UNITED STATES PATENT AND TRADEMARK OFFICE

| APPLICATION NO. | FILING DATE | FIRST NAMED INVENTOR | ATTORNEY DOCKET NO. | CONFIRMATION NO. |
|-----------------|-------------|----------------------|---------------------|------------------|
| 10/757,047 | 01/14/2004 | Heinrich Kladders | 1/1449 | 4842 |

Office Action Summary

DETAILED ACTION

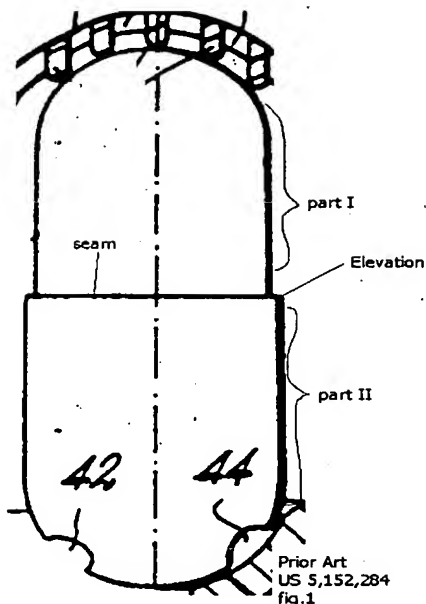
As to **claim 4**, Valentini teaches the method according to claim 1 wherein the capsule has elevations on its outer surface (see labeled fig.1, attachment below).

- As to **claim 6**, Valentini teaches the method according to claim 1 wherein the capsule consists of two parts (see labeled fig.1, attached below) which can be pushed telescopically one inside the other along the longitudinal axis (fig. 1 of Valentini clearly depicts two parts of capsule (22) pushed telescopically).

As to **claim 8**, Valentini lacks the explicit teaching of wherein the capsule has tapering sealed ends. However, it should be noted that Valentini teaches a capsule where an upper and lower parts are sealingly engaged (see labeled fig.1, attached below) by the nature of upper and lower parts' diameter sizes. The narrower diameter upper part (part I, see labeled fig.1, attached below) of capsule 22 is considered tapering sealed end. Thus Valentini teaches wherein the capsule has tapering sealed ends.

- As to **claim 9**, Valentini teaches the method according to claim 6 wherein the seam created between the two parts of the closed capsule is offset from the center by 0 to 12% of the outer longitudinal length (see labeled fig.1, attached below).

As to **claim 10**, Valentini teaches the method according to claim 1 wherein the capsule comprises a member of the D- symmetry group in terms of its outer contour, irrespective of the seam between the two parts of the capsule and irrespective of any manufacturing tolerances (see labeled fig.1, attached below).

As to **claim 17**, Valentini teaches a capsule (fig.1, 22) for holding a pharmaceutical composition which, in the closed state, has a longitudinal axis and a transverse axis which is shorter in relation to the longitudinal axis (see fig.1, 22) and which consists of two parts which can be pushed telescopically inside one another along the longitudinal axis (see labeled fig.1, attached below), wherein the features forming the outer contour of the closed capsule are symmetrical with respect to a transverse plane which bisects the longitudinal axis, the following features being excluded from the conditions of symmetry (see labeled fig.1, attached below): fine structures of the seams which are produced by the sealing of the seams of the individual parts of the capsule, and/or elements formed on the capsule surface which are smaller than 0.1 mm, and/or angles of taper up to 5° (see “elevation” in the labeled fig.1, attached below).

As to **claim 18**, Valentini teaches the capsule according to claim 17 wherein the seam created between the two parts when the capsule is closed is offset from the center by 0 to 12% of the outer longitudinal length (see labeled fig.1, attached below).

As to **claim 19**, Valentini teaches the method according to claim 1 wherein the capsule comprises a member of the D- symmetry group in terms of its outer contour, irrespective of the seam between the two parts of the capsule and irrespective of any manufacturing tolerances (see labeled fig.1, attached below).

As to **claim 20**, Valentini teaches the capsule according to claim 17 wherein features located on the outer contour (see labeled fig.1, attached below) of the capsule surface and forming a symmetrical pair may have a tolerance and inaccuracy deviating from the symmetry of 0.15 mm in each case (see labeled fig.1, attached below).
